113027 - 00

Change Notification #: 113027 - 00
Change Title: Intel® Integrated RAID Module
RMS25PB040, RMS25PB080, and
RMT3PB080
PCN 113027-00, Product Design
Update Firmware, Change Serial Bootstrap
Room (SBR) Setting, Remove the R5M45
Resistor
Date of Publication: May 15, 2014

Figure 1. R5M45 pull-down resistor location

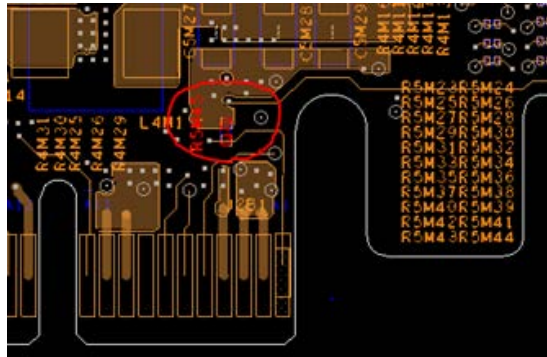
3. Remove the R5M45 pull-down resistor from the PRESENT# detection circuit on the RAID module. This change will prevent the situation that an additional PCIe* bridge device may be falsely recognized by the server system if the RAID module is installed on the PCIe* slot which can support both the PCIe* adapter and riser. See Figure 1 below.
